Administrative Manual - Team UPDATE - 2013-02-22	4
Administrative Manual - Team UPDATE - 2013-02-22	5
Administrative Manual - Team UPDATE - 2013-02-19	6
Administrative Manual - Team UPDATE - 2013-02-19	7
Administrative Manual - Team UPDATE - 2013-02-19	8
Administrative Manual - Team UPDATE - 2013-02-19	9
Administrative Manual - Team UPDATE - 2013-02-15	10
Administrative Manual - Team UPDATE - 2013-01-29	11
Administrative Manual - Team UPDATE - 2013-01-25	12
Game Manual - Team UPDATE - 2013-02-22	13
Game Manual - Team UPDATE - 2013-02-19	14
Game Manual - Team UPDATE - 2013-02-19	15
Game Manual - Team UPDATE - 2013-02-15	16
Game Manual - Team UPDATE - 2013-02-12	17
Game Manual - Team UPDATE - 2013-02-12	18
Game Manual - Team UPDATE - 2013-02-08	19
Game Manual - Team UPDATE - 2013-02-08	20
Game Manual - Team UPDATE - 2013-02-05	21
Game Manual - Team UPDATE - 2013-02-05	24
Game Manual - Team UPDATE - 2013-02-05	25

Game Manual - Team UPDATE - 2013-02-22

Figure 2-9: ROBOT Using Belay Device (UPDATED)

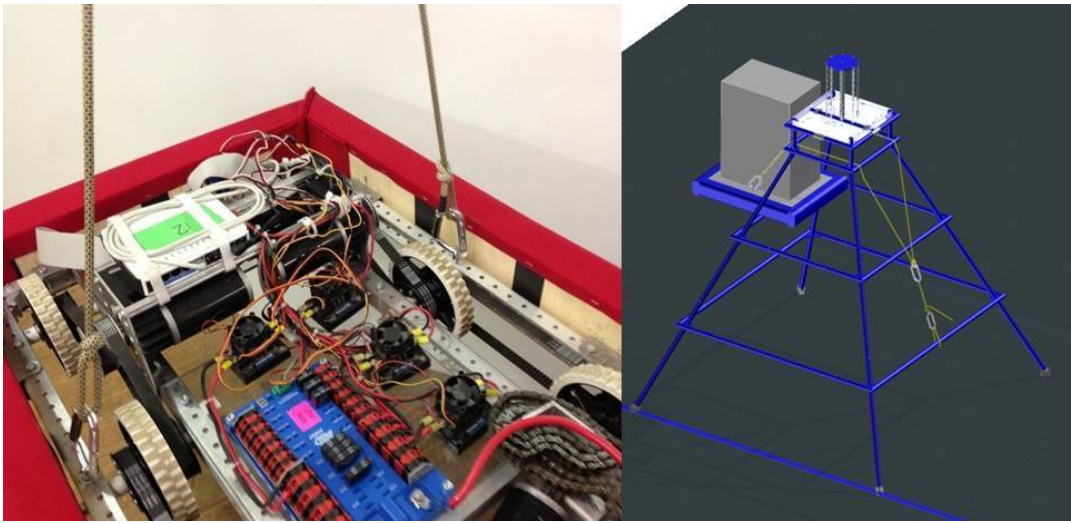
Teams may have to remove their ROBOT from the PYRAMID after the MATCH is over with the aid of a *FIRST* supplied belay system, per [G04](#). The belaying device acts as a brake to prevent accidentally dropped ROBOTS from causing injuries to teams. The device attaches to the ROBOTS with two carabiners or loops of rope. Teams must supply two attachment points for the belaying device to mount to their ROBOTS, per R10. The belaying rope is fed through a brake that is anchored to the lowest rung on the opposite side of the PYRAMID from the ROBOT. It is then fed through the PYRAMID top and down the other side to be attached to the ROBOT. There is a "bridle" that splits the rope into two sections, which are 90 in. long.

Only trained event staff are allowed to use the belaying device.

Figure 3-5b: Offset Plane from PYRAMID Base

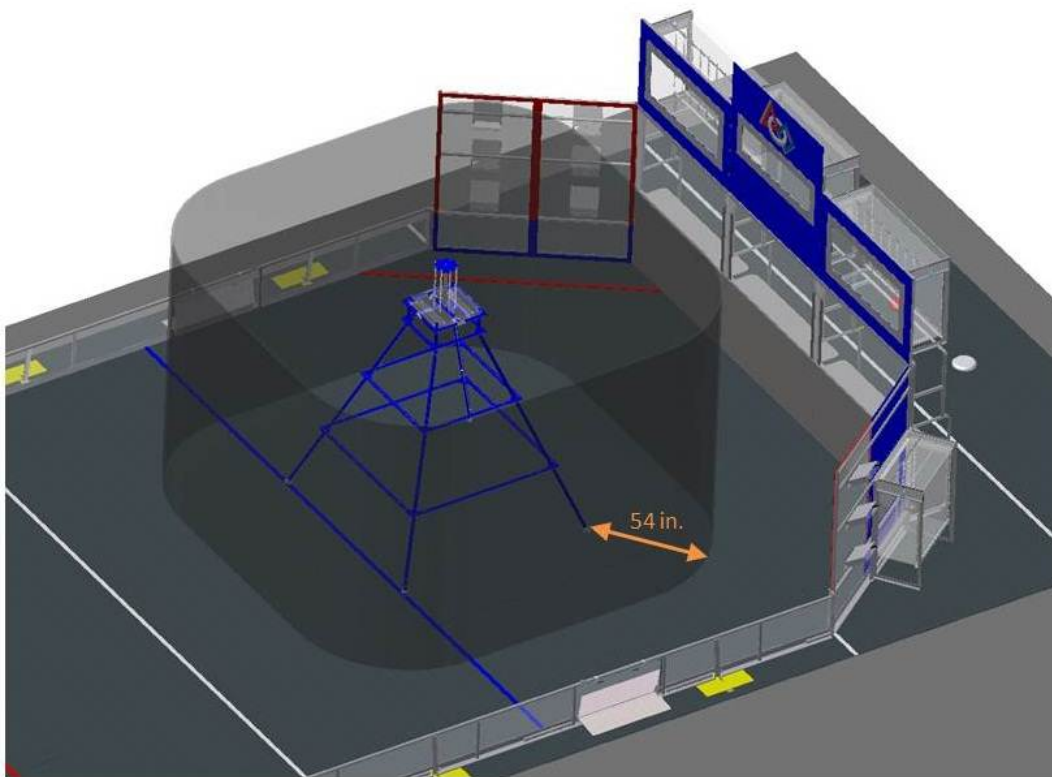
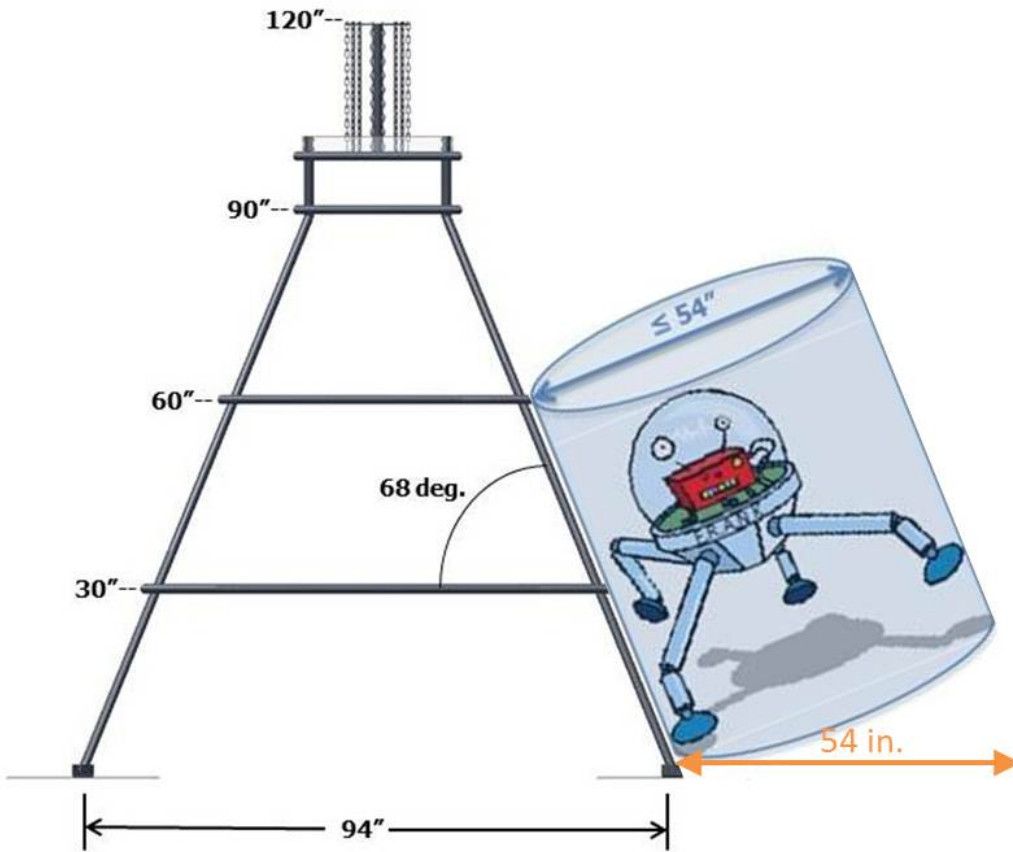
While in contact with the PYRAMID, a ROBOT

- A. may not have its horizontal dimensions exceed a 54 in. diameter vertical cylinder relative to the ROBOT and
- B. may not extend any part of itself beyond a vertical plane defined by a perimeter offset from the base of the PYRAMID by 54 in., see Figure 3-5b and Figure 3-5c.

Figure 4-1: FRAME PERIMETER Length Calculations

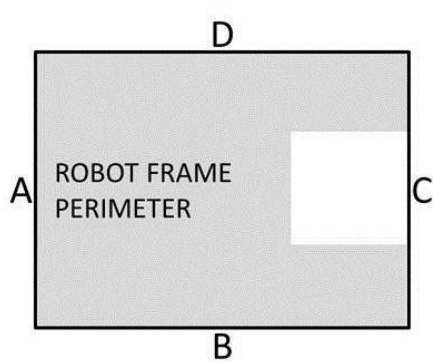
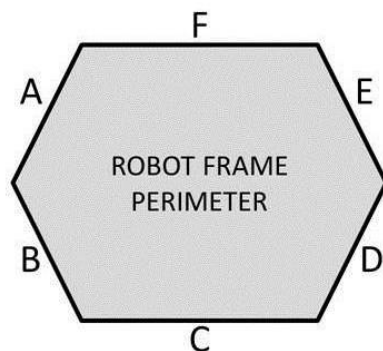
- A. total length of the FRAME PERIMETER sides may not exceed 112 in. (see [Figure 4-1](#) for examples),
- B. PLAYING CONFIGURATION horizontal dimensions may never exceed a 54 in. diameter vertical cylinder (see [G23](#) and [G23-1](#)), and
- C. height may never exceed 84 in. tall.

Expect to have to demonstrate a ROBOT'S ability to constrain itself per B above during Inspection. PLAYING CONFIGURATION constraints may be implemented with either hardware or software.

Figure 4-2: BUMPER Corner Examples (UPDATED)

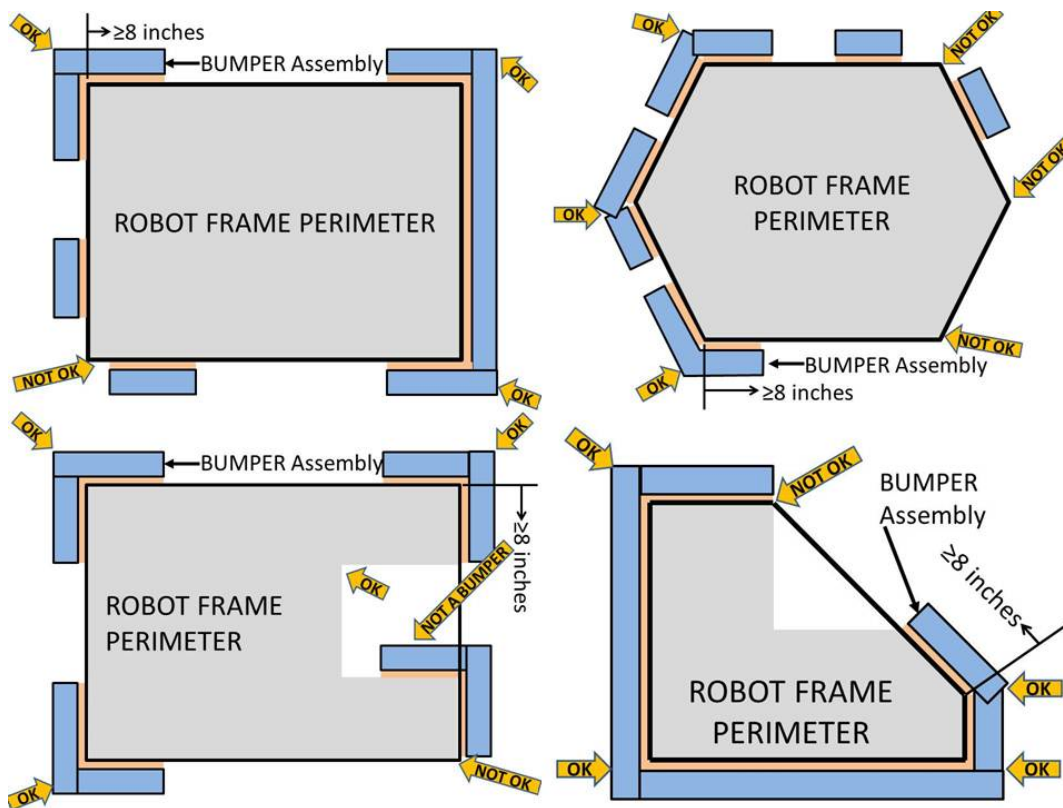
ROBOTS are required to use BUMPERS to protect all outside corners of the FRAME PERIMETER. For adequate protection, at least 8 in. of BUMPER must be placed on each side of each outside corner (see [Figure 4-2](#)).

The dimension defined in R22 is measured along the FRAME PERIMETER. The portion of the BUMPER that extends into the corner is not included in the 8 in. requirement.

Figure 2013-01-15

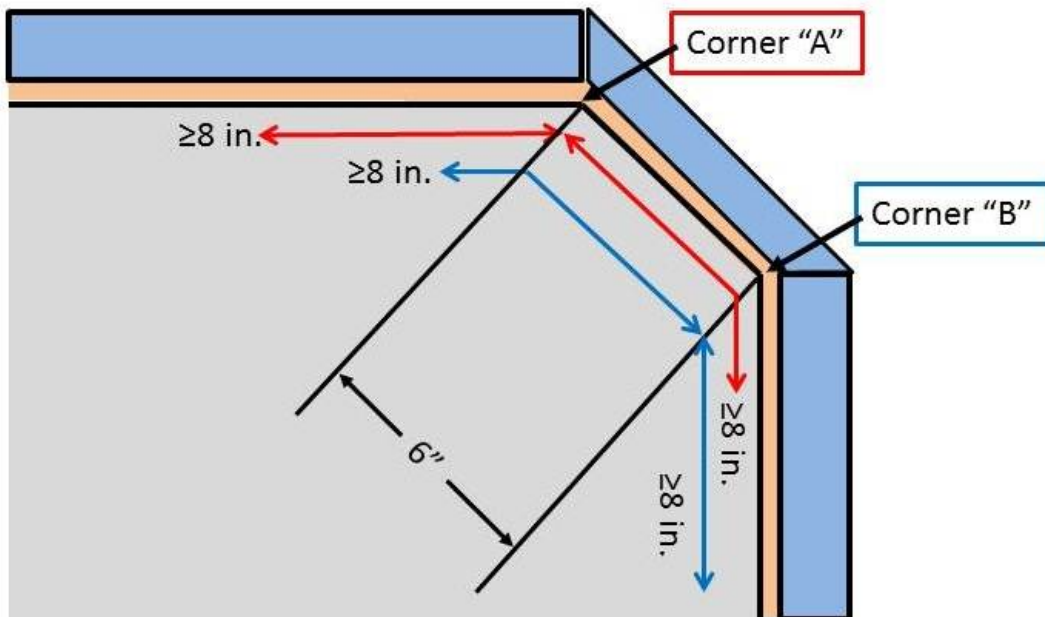
The Inspectors also asked for clarification on the 8 in. BUMPER requirement of R22. As stated in the Blue Box on R22, the dimension is measured along the FRAME PERIMETER. In Figure 2013-01-15 below, the edge of the FRAME PERIMETER between Corner A and Corner B is only 6 in. To satisfy the 8 in. requirement for Corner A, there must be at least 8 in. of BUMPER in each direction. Thus, the measurement along the 6 in. side would continue past Corner B for 2 more inches.
